DATE: May 21, 2018
TO: Keith Davis, Superintendent
FROM: Bret Highley *ABH*
RE: Change Order #8 – Bullitt Lick Middle School
Roof Abatement and Replacement

Change Order

CHANGE ORDER REQUEST NO. 008

PROJECT: BULLITT LICK MIDDLE SCHOOL
RENOVATION AND ADDITION
BG# 17-148
ska# 2016-86

1 ROOF PLAN - PLUMBING
 1/16" = 1'

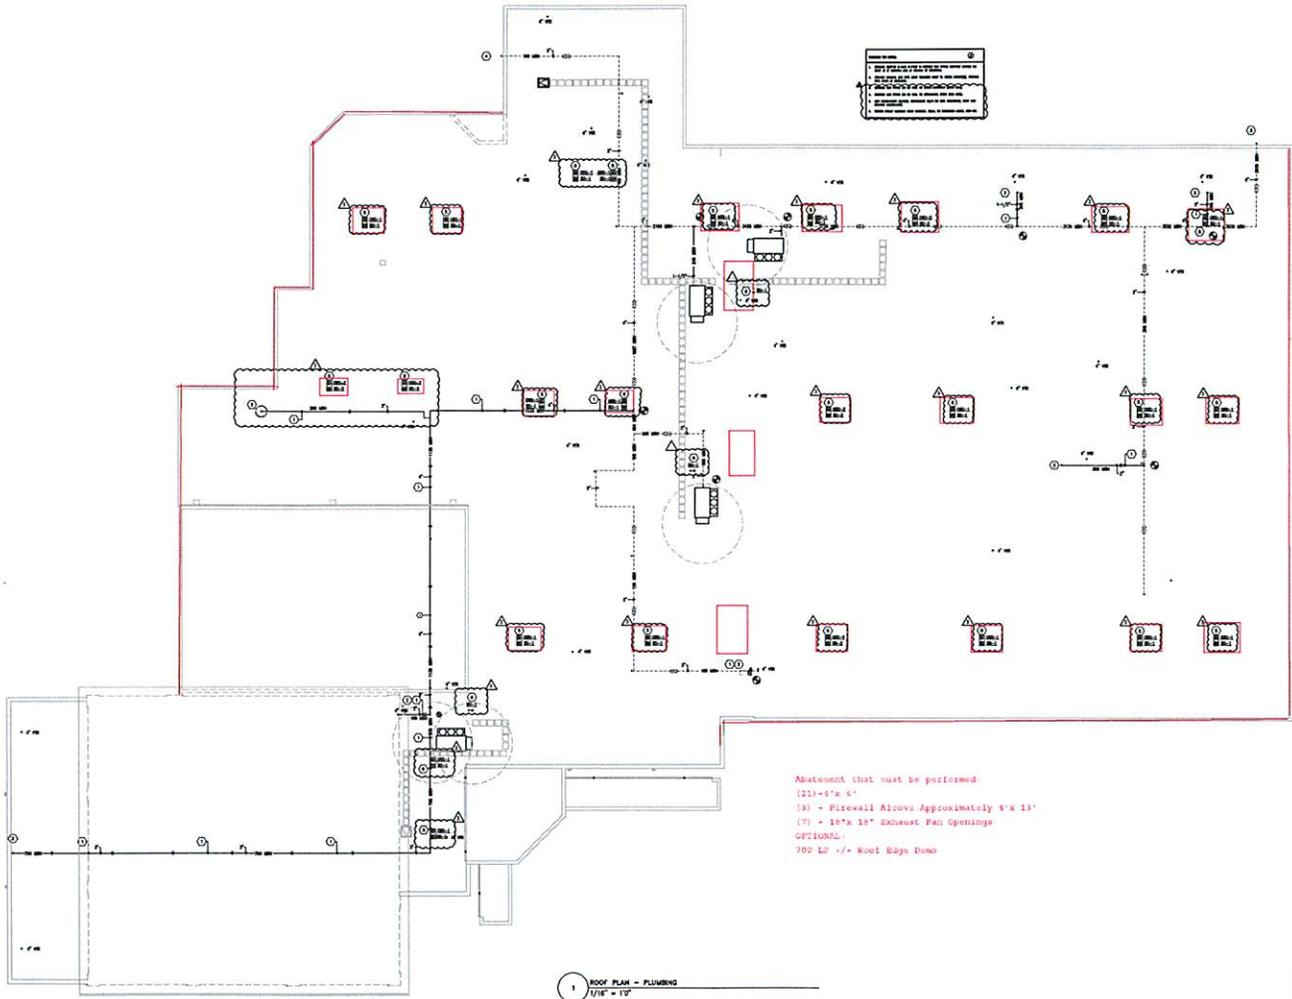
Option #1: Abatement of the roof penetrations for the roof drains, alcoves and exhaust fans (21-4'x 6' areas, 3 - 4'x 13' Firewall Alcove area, 7 - 18"x 18" Exhaust Fan Openings).

Option #2: Abatement of up to 700 LF of roof edge / flashing.

Option #3: Abatement of entire roof (up to 63,500 SF) to the Tectum decking.

Abatement that must be performed
 (21)-4"x 6"
 (3) - Firewall Alcove Approximately 4'x 13'
 (7) - 18"x 18" Exhaust Fan Openings
 OPTIONAL:
 700 LF +/- Roof Edge Duro

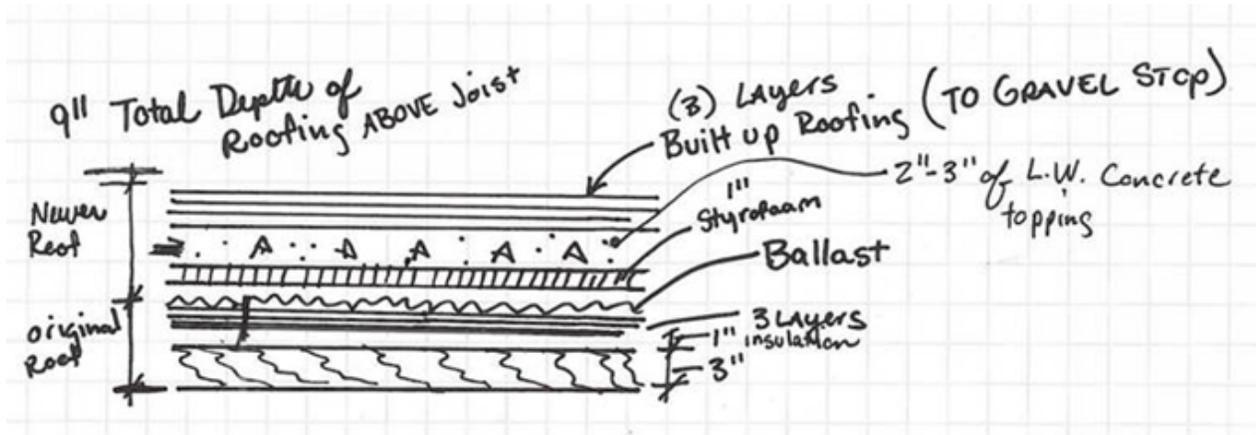
EH Construction alerted Studio Kremer Architects and BCPS district staff to an unforeseen condition at the roof on April 27, 2018. The roof composition found at BLMS is different than what was assumed based on original documents. The roof composition found lead the A/E and Construction team to believe the original roof was left in place and a new roof was built over it that included a 2" – 3" layer of light weight concrete. The roof layers are noted and illustrated below:

Newer Roof over Original

- (3) Layers Built up Roofing
- 2"-3" Light Weight Concrete
- 1" Foam Board

Original Roof

- Ballast
- (3) Layers Built-up Roofing (CONTAINS ASBESTOS)
- 1" Insulation/Cover Board
- 3" Tectum Deck

Working together with EH Construction, the design team looked at options for selectively demolishing specific layers of the roof and encapsulating the asbestos layer but found this is not possible. The reason for this is two-fold: (1) the ballast layer cannot be disturbed due to the asbestos layer being directly below it, which would require abatement, and (2) the ballast layer’s weight exceeds the allowable maximum load once a new foam roof is added on top of it. Because of both the risk of asbestos contamination and the ballast layer causing the roof to exceed allowable weight limits we are in a position to only recommend one option to deal with the existing roof condition - the existing roof assembly must be removed in its entirety down to the existing tectum roof deck.
